A.12-05-020/SOCRE

San Diego Gas & Electric Company (SDG&E) has worked diligently to respond to each of the questions you posed in your June 15 2012 Completeness Review letter. The original text for each item of the completeness review is included in bold, followed by SDG&E's response in plain text.

**DISTRIBUTION LINE PROJECT DESCRIPTION**

Sheet 1 of 5

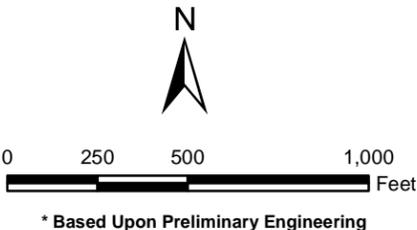
*Section 3.4.4, Distribution Lines, of the PEA discusses alterations to distribution lines and substation equipment that would be components of the proposed project, but also indicates that, because the CPUC “does not regulate distribution infrastructure,” the potential impacts of these project components are not analyzed within the PEA document. A fuller description of these components, and an analysis of their impacts, is required to be included as part of the PEA.*

*A too-narrow definition and analysis of project components can result in piecemealing, or the “fallacy of division,” in which case the details of the project and the total impact of the project are not disclosed accurately.<sup>2</sup> Although the individual parts of a project may themselves have a minor or minimal impact on the environment, such impacts taken as a whole could result in a significant impact.<sup>3</sup> For these reasons, the current PEA is deficient, and a supplement that includes a complete analysis of the impacts of the distribution and substation components that are acknowledged to be part of the proposed project is required.*

SDG&E hereby withdraws the erroneous statement on page 3-79 of the PEA that “The CPUC does not regulate distribution infrastructure”. Below is a description of the required distribution work component of the South Orange County Reliability Enhancement Project (Proposed Project). Additional information, including an analysis of potential impacts relating to the required distribution line work, will be provided in a subsequent submittal.

Circuits 196, 197, and 315 will be relocated outside the San Juan Capistrano Substation to accommodate the new 230kV line connection (refer to Proposed Distribution Map, Sheet 1). The existing distribution getaway from the substation to Junipero Serra Park, east across Calle Santa Rosalia, has Circuits 196 and 197 attached to an existing overhead distribution-only pole line on the south side of Junipero Serra Park. Circuit 315 from the substation east is under-built on existing 138kV transmission poles in Junipero Serra Park and crosses the Interstate 5 (I-5) freeway. A section of Circuit 315 will be removed to accommodate the new 230kV transmission lines.

**Figure 3-7**  
 Sheet 1 of 20  
 Updated: 7/6/2012

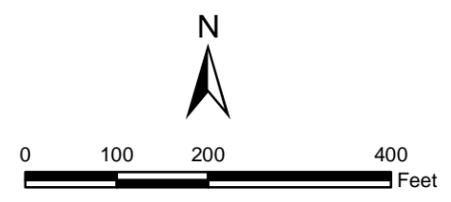
*In order to accurately describe and assess the entire proposed project footprint and area of disturbance, a description of the access roads that would be modified or constructed is required to complete the applicant’s PEA. The PEA includes general discussion indicating that access roads would be used, modified, and created during construction to the proposed project, and Figure 3-7 shows existing access roads in the project area, but the PEA does not clearly identify areas where existing roads would be improved or where new access roads would be required. In order to correct this deficiency, supplemental information identifying the location of any road widening and other improvements, as well as new access/spur roads that would be required for the project, is required. This information should be submitted either as an addition to Figure 3-7 (additional map layer), or as a new PEA figure, as well as in the form of GIS data. A textual description of these components is also required.*

Work Required to Access and Spur Roads and Purpose	Location Relative to the Proposed Project	Location on Figure 3-7
<b>IMPROVEMENTS TO EXISTING ROADS</b>		
Temporary and permanent road improve/widening. Widen road up to approximately 4 feet during construction. Improvements required to allow for vehicle access.	Access to Pole No. 4	Sheet 1
Improve existing access to pole site as part of construction of new pole and construction/maintenance pads.	Access to Pole No. 5	Sheet 1

Figure 3-7 depicts project work areas based on preliminary design and is a more specific depiction of the general description of 150 feet by 150 feet. Therefore, the approximately 9.66 acres identified in the PEA is an accurate estimate of work area based on design concepts completed for the PEA. Work areas are also further defined per the previous response and the updated Figure 3-7, Attachment 2.
